CB24-E-001

JUNE 2024

IMPORTANT SAFETY RECALL

F-SERIES TIE ROD INSPECT & REPLACE – V2402

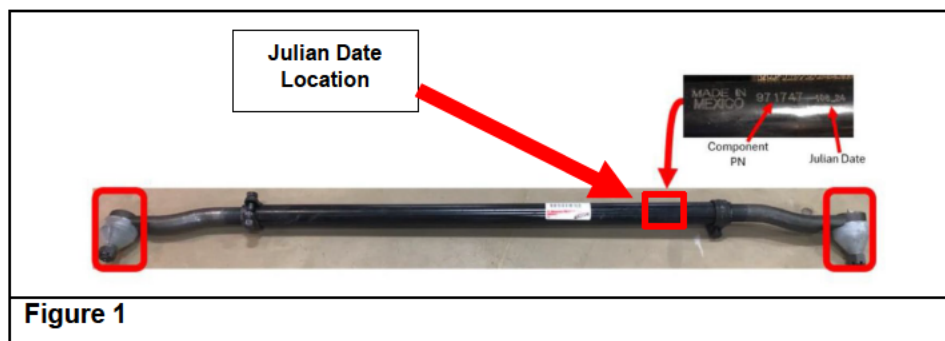
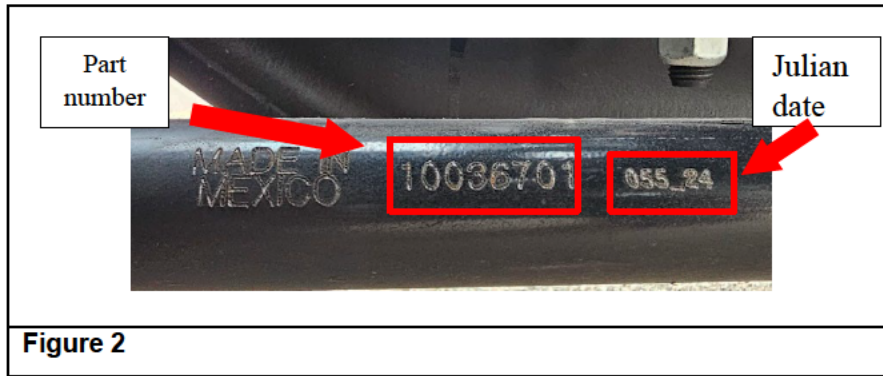
3. For the following 3 VINs, locate the information of the component part number and Julian date stamped on the steering tie-rod assembly center tube as shown in Figures 1 and 2.

4. Record the Part Number and Julian date code.
5. Take a photo of the Part Number and Julian date code.
6. Call the Isuzu Technical Assistance Center (TAC) at Telephone Number: 1-877-ISUZUCV (1-877-478-9828), follow the prompt. Provide the photo(s) and recorded information to the TAC representative. The information will be reviewed by Isuzu and you will be contacted with directions for how to complete the recall for your vehicle. These three (3) vehicles must remain on hold and **are not to be driven** until further notification is received.
